From: Molony, Anne TRAN:EX
Sent: Wednesday, May 7, 2014 2:58 PM
To: 'Bill Wheeldon'
Subject: RE: 432 Powerhouse Road - RAR Assessment Draft/for your info

From: Molony, Anne TRAN:EX
Sent: Thursday, May 29, 2014 3:17 PM
To: 'Dusty Silvester'
Subject: RE: Timberlane Rd culvert/driveway installation - Environemntal Protection Plan

RE: ENVIRONMENTAL PROTECTION PLAN FOR CULVERT/DRIVEWAY INSTALLATION AT
LOT A PLAN 25007 DstLot 155 LndDst 15

From: Molony, Anne TRAN:EX
Sent: Tuesday, August 19, 2014 2:11 PM
To: 'Bill Wheeldon (s.22
Subject: Permit 2014-00402 - Timberlane Road

Section 3. – Figure 2. Site Plan

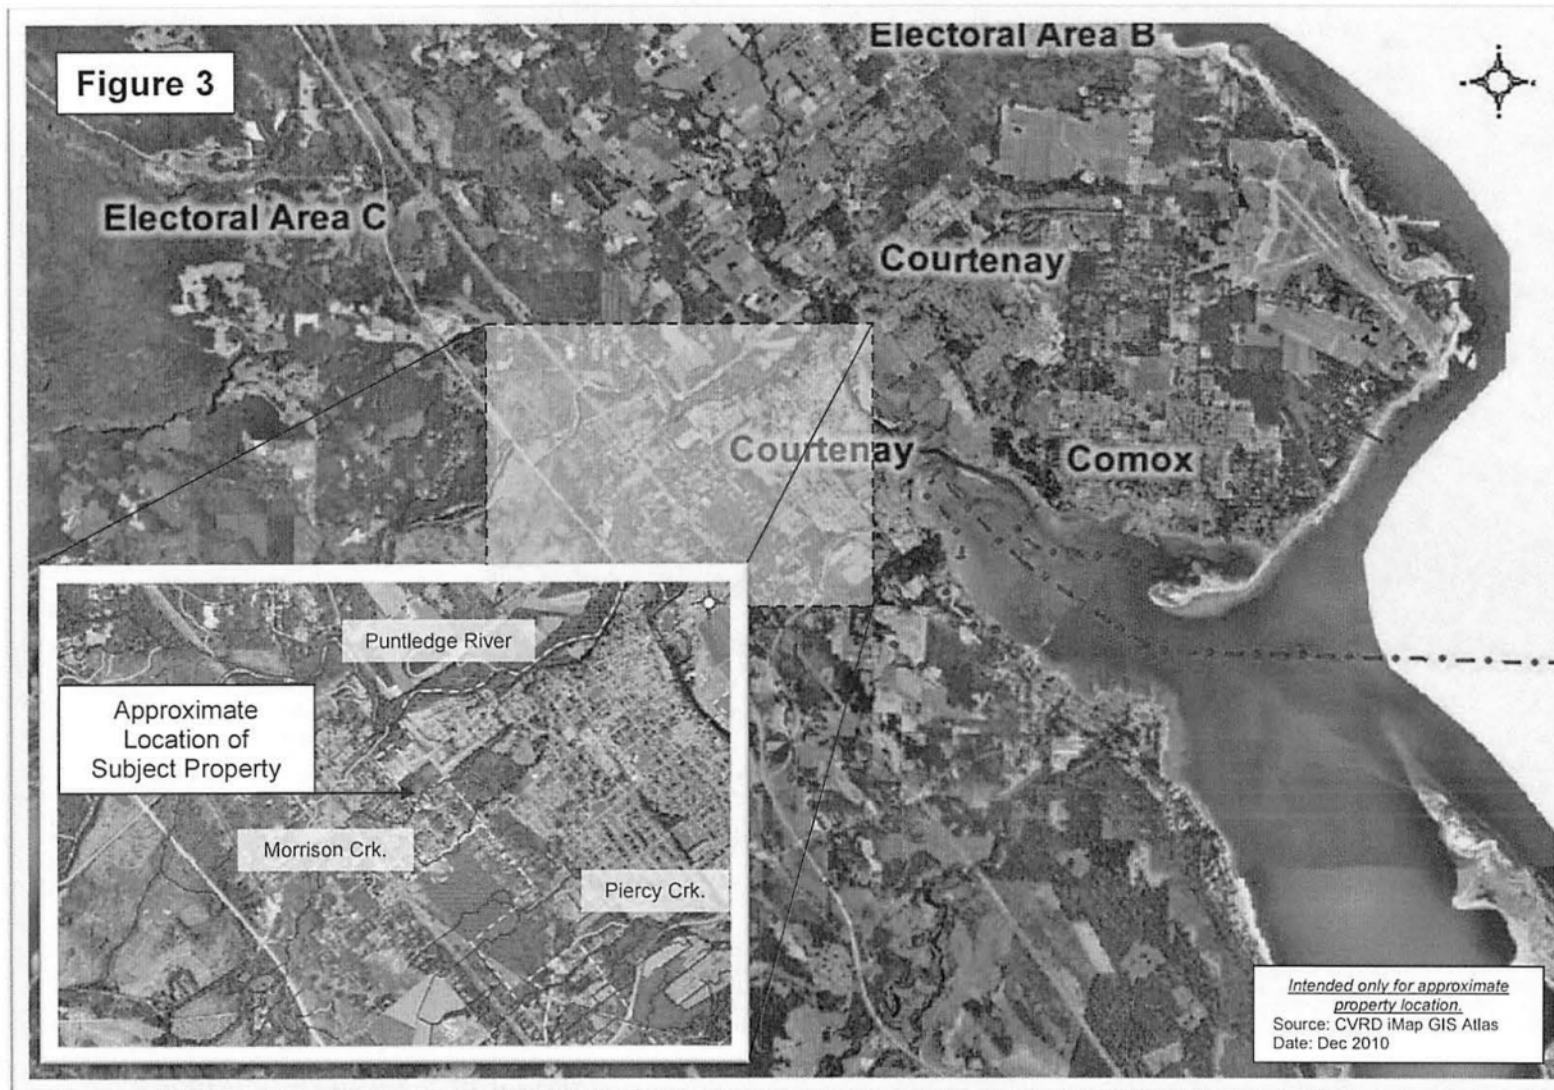
Thanks for a copy of the report, however, it does not specifically address the proposed driveway access nor does it speak to how the ditch is going to be crossed – suitable structure and mitigation factors. The report goes in to detail regarding the fence and footbridge but has no mention of the practices required to cross Timberlane Ditch. I require:

- A design plan showing the layout of the proposed extension/driveway
- An assessment from a qualified professional regarding the appropriate size of culvert and sediment mitigation factors

Photos from
Aug. 19, 2014

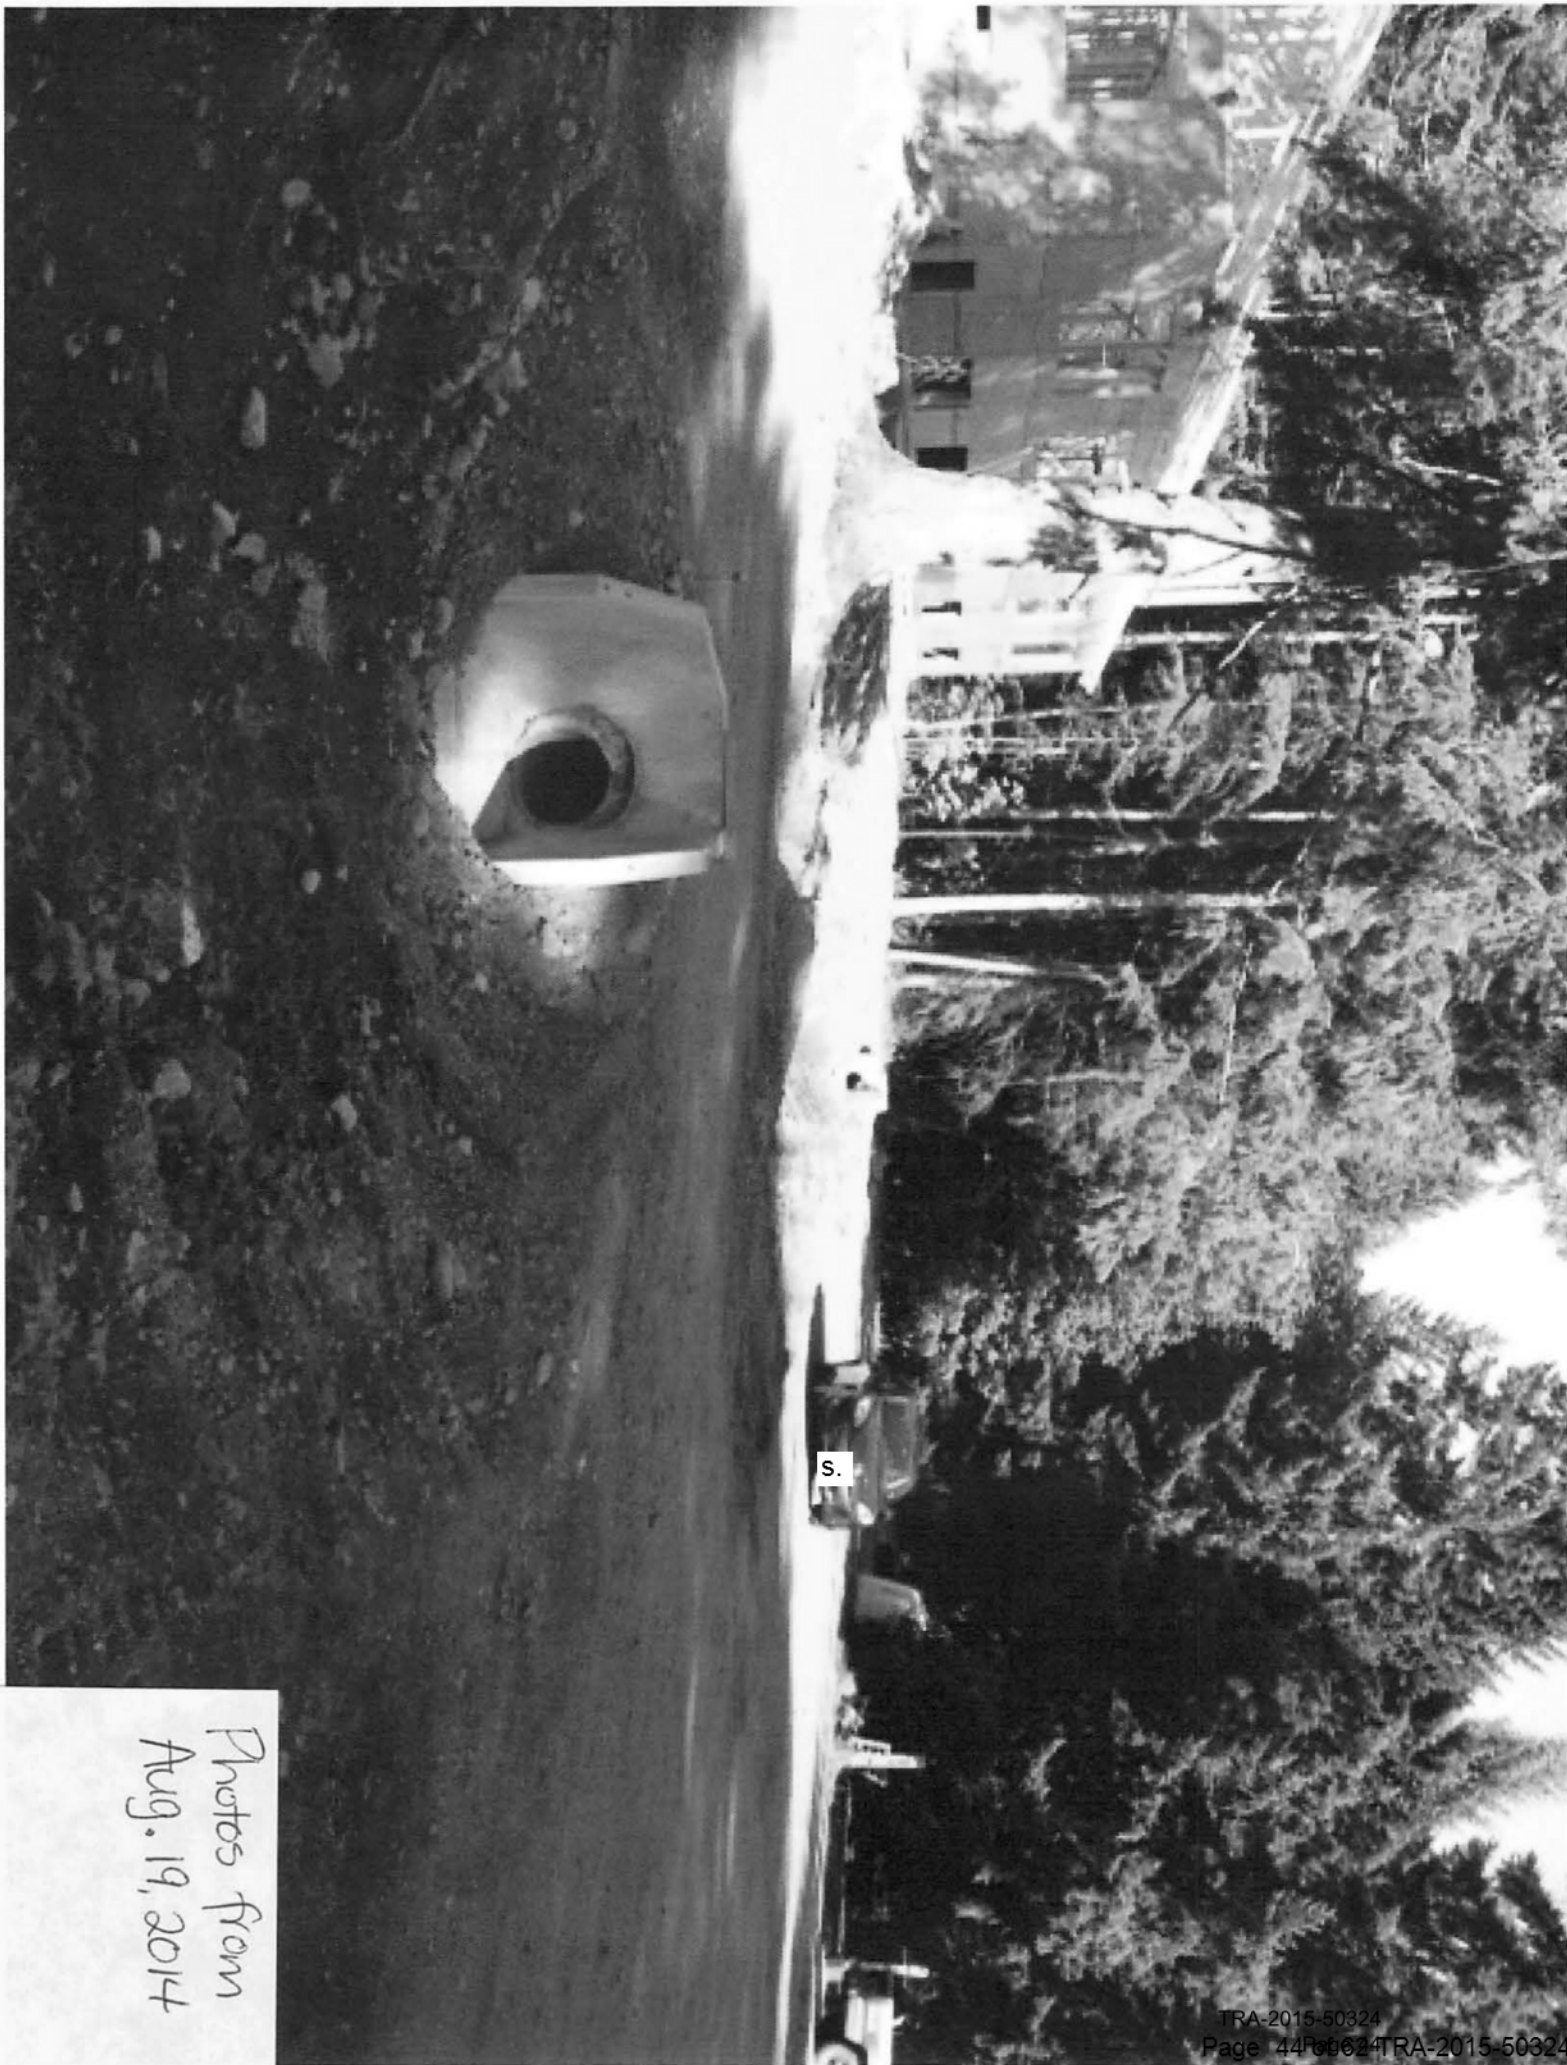
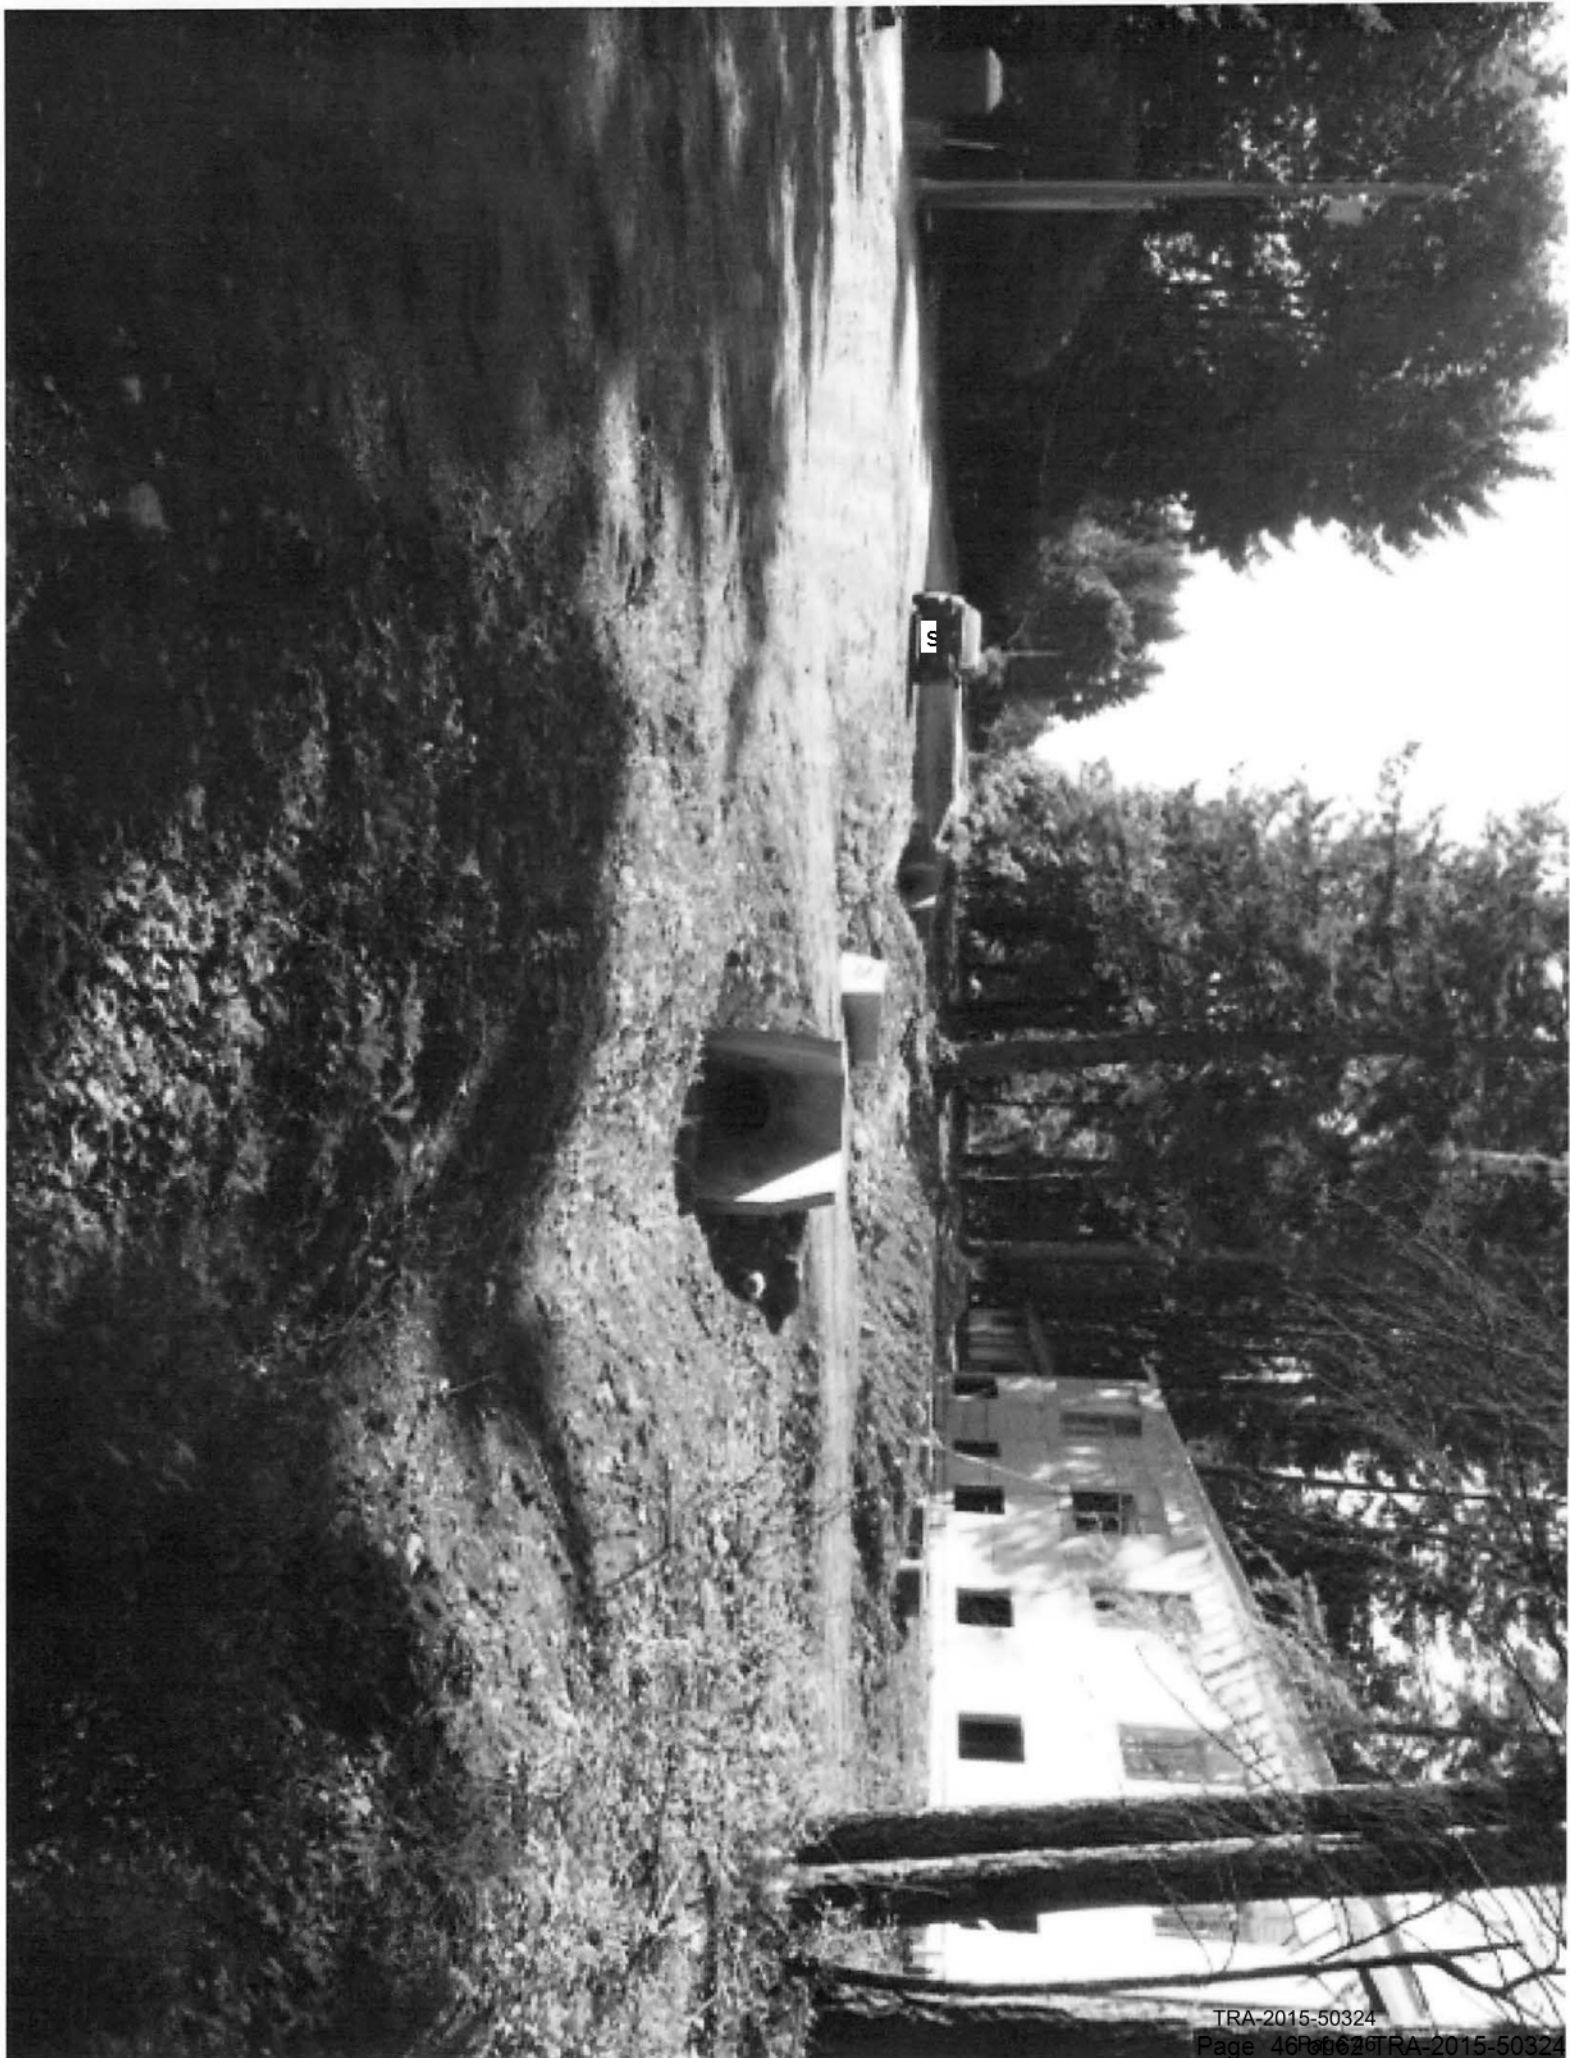
I was out reviewing the secondary driveway on Timberlane Road this morning. There are few outstanding items that need rectifying, specifically:

- the vegetation was supposed to be left intact along the ditchline, this has been removed and requires grass seeding along with all other areas within the right-of-way with exposed soils
- the headwalls on the driveway culverts are raised well above grade, these need to be infilled/contoured - what are the driveways going to be finished with?
- there is a white pipe (see attached photo) exiting into the ditch, no water may be diverted from within the bounds of the property into the ditch, ditches are in place to manage road water, not property owner's perimeter drains, etc. - this pipe requires removal

Please let me know if any further explanation is required. My company will be undertaking the seeding of the exposed ditchline, and if you like I can contact you when the work is complete: likely in April but timing is weather dependent.
